STAFF REPORT
KETCHUM PLANNING AND ZONING COMMISSION
REGULAR MEETING OF TUESDAY, SEPTEMBER 15, 2020

PROJECT: Gem Street Subdivision LLS

FILE NUMBER: P20-071 (Lot Line Shift) and P20-074 (Waiver Request)

REQUEST: Preliminary Plat Lot Line Shift to reconfigure two existing lots and waiver request to allow the creation of a new double-frontage lot

Figure 2.
Proposed Lot Configuration

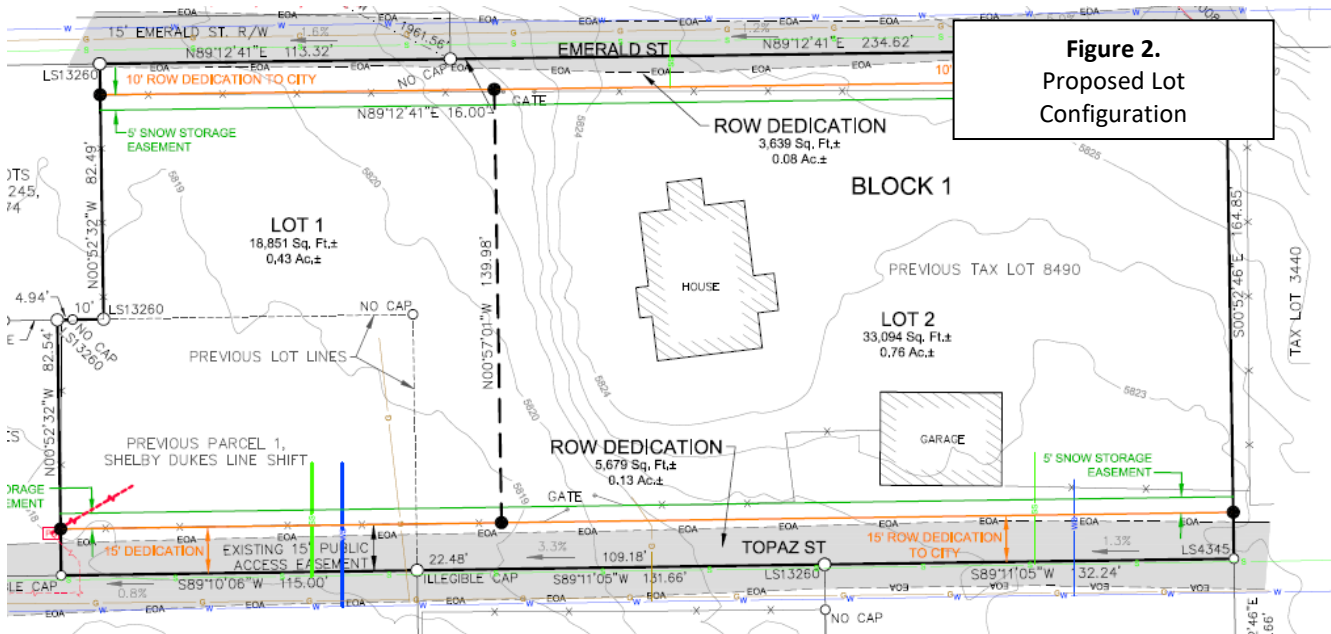
The Lot Line Shift action would reduce 151 Topaz to 0.76 acres in size and enlarge 131 Topaz to 0.43 acres in size. The proposed reconfiguration would also provide 131 Topaz with street frontage on Emerald, which would change this lot from a single-frontage lot into a double-frontage lot.

The lots proposed by this action will meet all zoning dimensional standards (see Attachment D, draft Findings of Fact, Conclusions of Law, and Decision, table 2, Dimensional Standards). However, the creation of new double-frontage lots is prohibited by the Subdivision Ordinance (§16.04.040.F.5). But, the Subdivision Ordinance provides an opportunity for applicants to request waivers (§16.04.130). The applicants have requested a waiver from this standard so that 131 Topaz may be reconfigured into a double-frontage lot.

A PLAT SHOWING GEM STREET SUBDIVISION

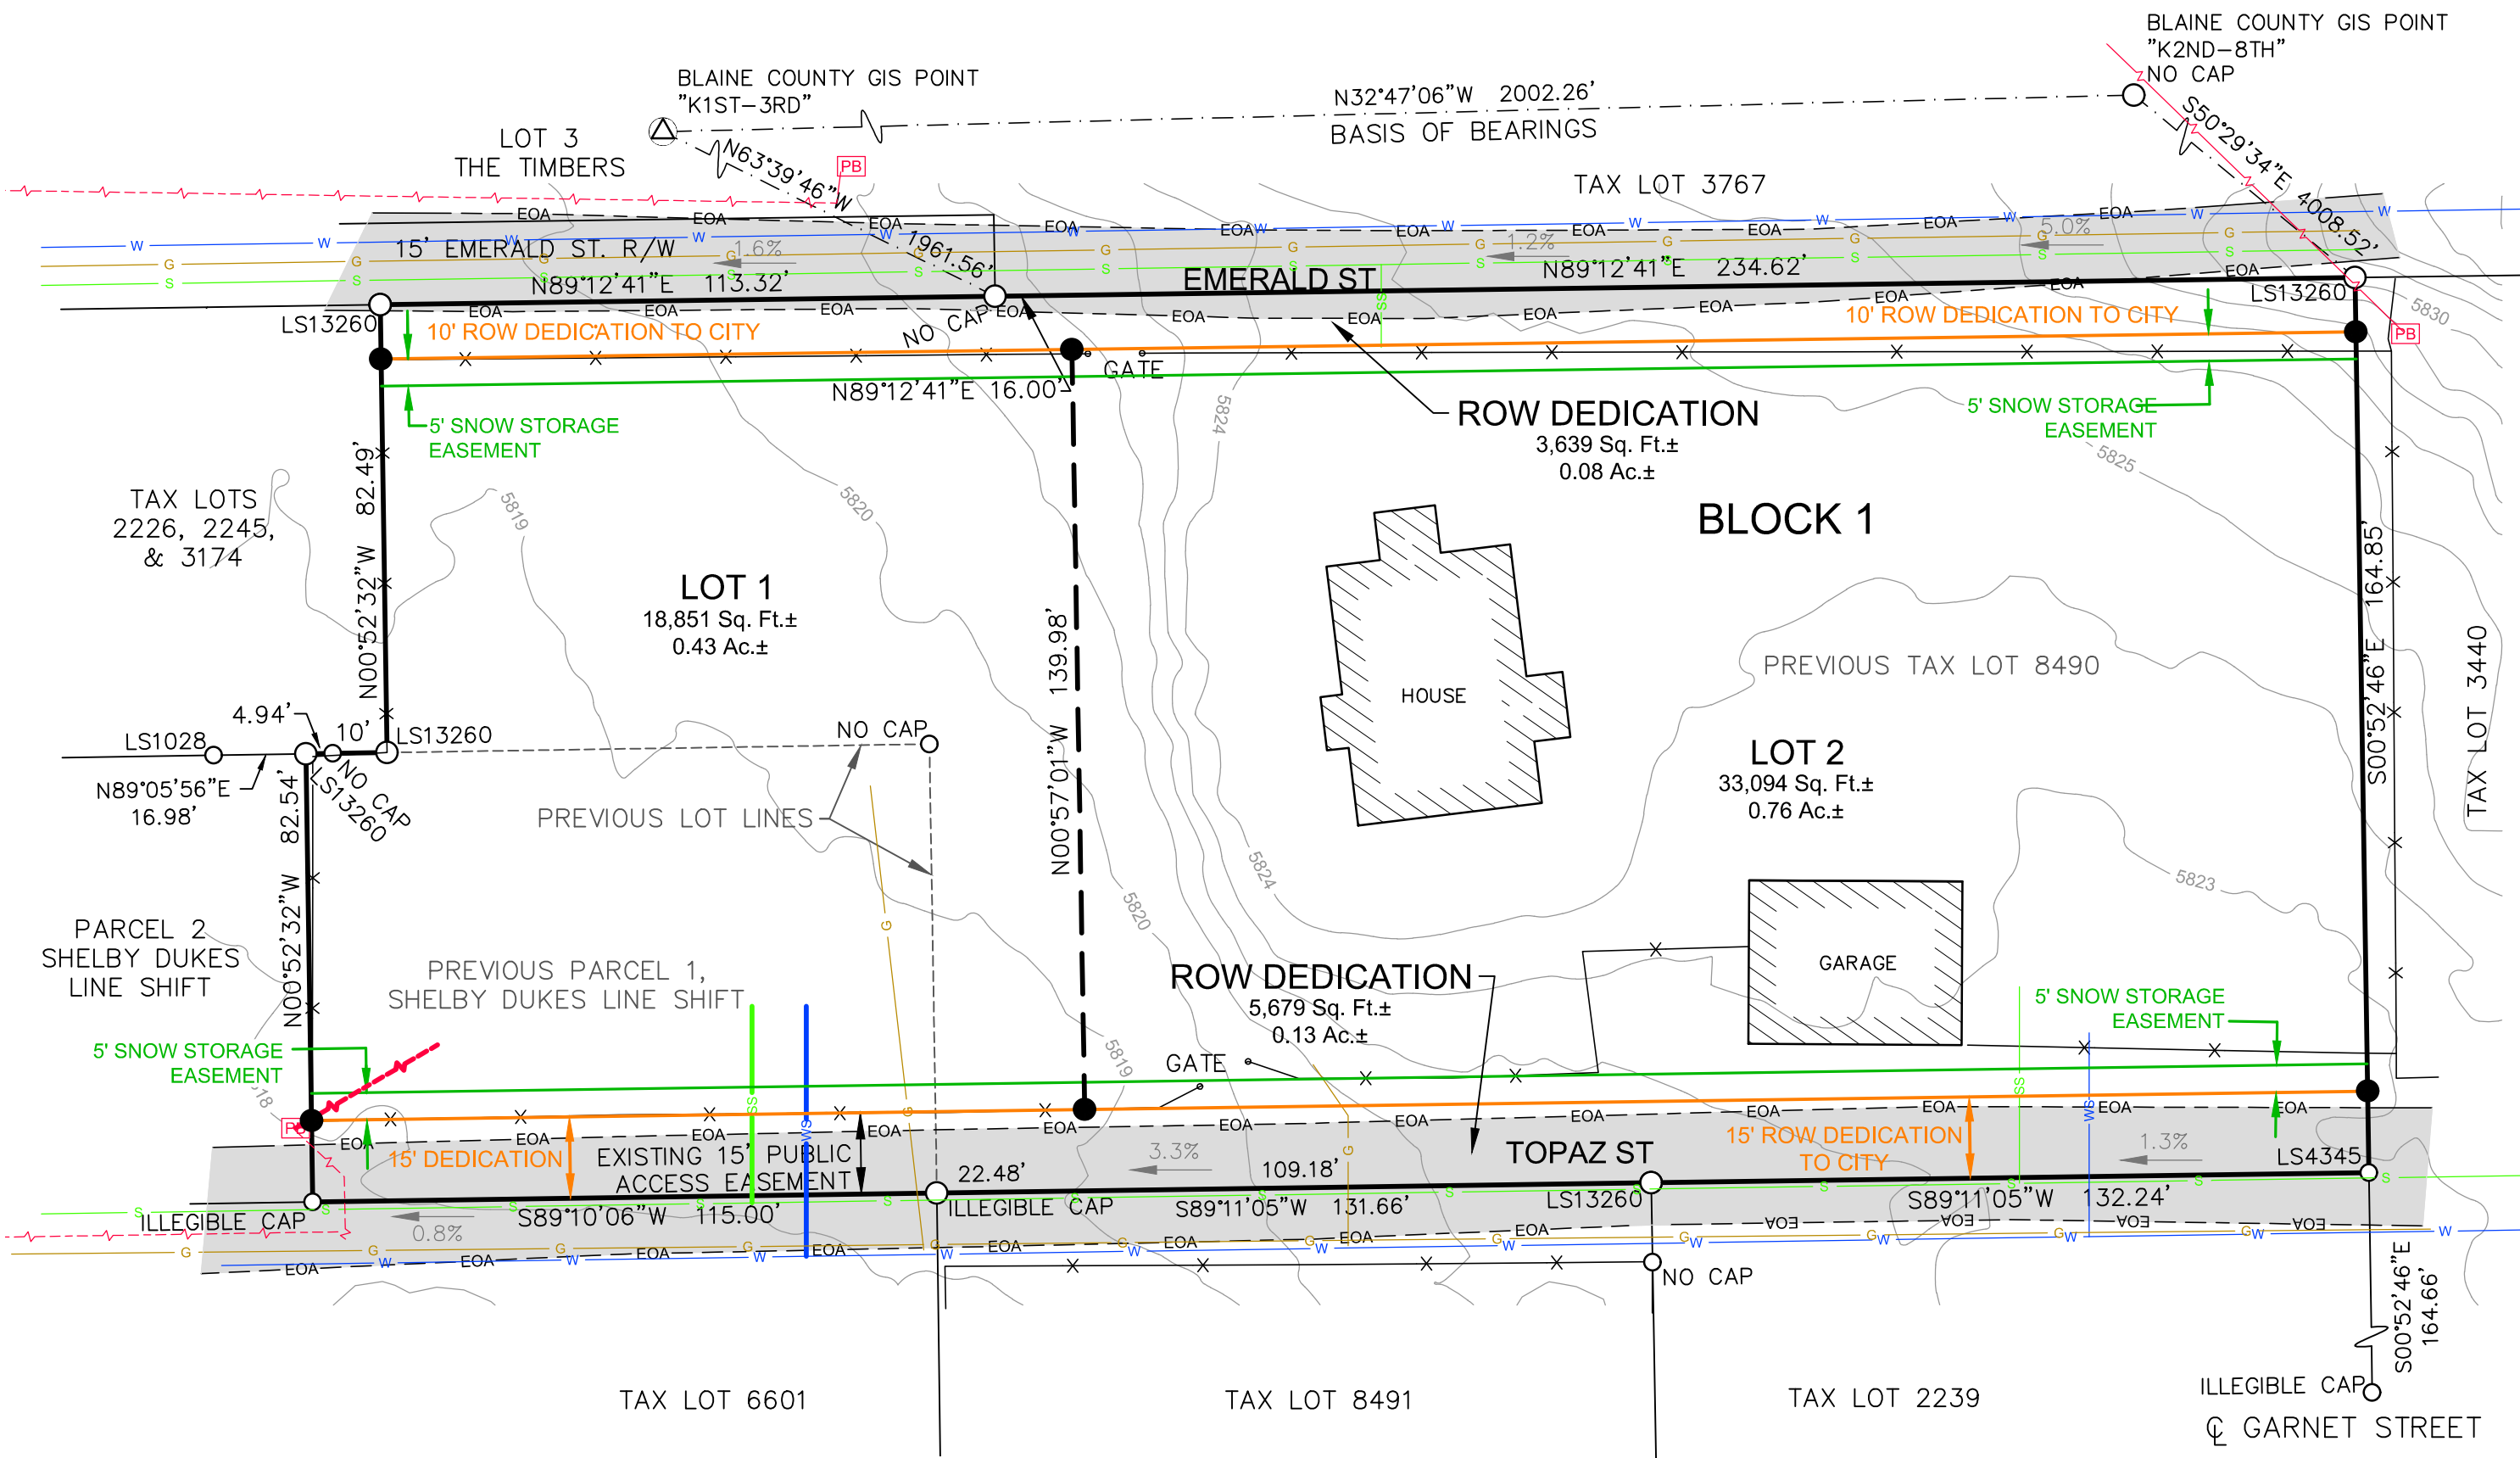
Regarding the right-of-way dedication: the subject parcels have frontage on portions of Emerald Street and Topaz Street that are currently absent of city-owned right-of-way; both streets currently traverse private property. The subdivision ordinance requires dedication of right-of-way to the city and this application proposes dedicating right-of-way 15’ in width along Topaz Street and 10’ in width along Emerald Street.

Lastly, because Topaz and Emerald Streets do not meet city standards and will remain substandard, even with the dedication of right-of-way, two additional actions are required of this subdivision: parking of vehicles in the area dedicated as right-of-way will be prohibited (see Plat Note #7) and the new property boundaries for each parcel will include 5’ snow storage easements on the street-fronting sides. The easements are to remain free and clear. Existing fences are permitted to remain within the easement area until redevelopment of each property, subject to indemnification of the city for damages (see Plat Note #5).

1. An Indemnification Agreement, indemnifying the city for damages to the existing fences located on both lots, shall be recorded prior to recording the Final Plat and the instrument number for the Agreement shall be indicated on the Final Plat; and

3. The recorded plat shall show a minimum of two Blaine County Survey Control Monuments with ties to the property and an inverse between the two monuments. The Survey Control Monuments shall be clearly identified on the face of the map; and
